RE: Eaton Middle School; NPDES Permit # 1GC04065*AG; Compliance Inspection Findings and New Athletic Facilities-Phase 1, Eaton High School; NPDES Permit # 1GC04459*AG; Compliance Inspection Findings and Notice of Violation

Ohio EPA DSW Storm Water Section, Construction Site Visit Information Form

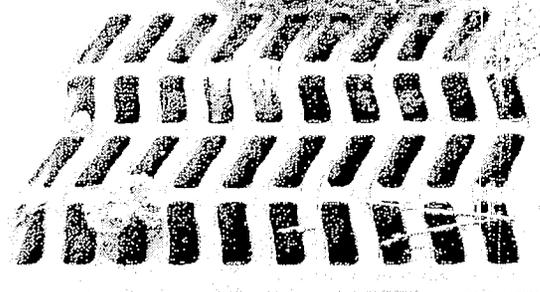
5. Are BMPs effective? All Some None No BMPs

Explain: South side of parking lot had ~~an~~ an unfunctional Dandy Bag
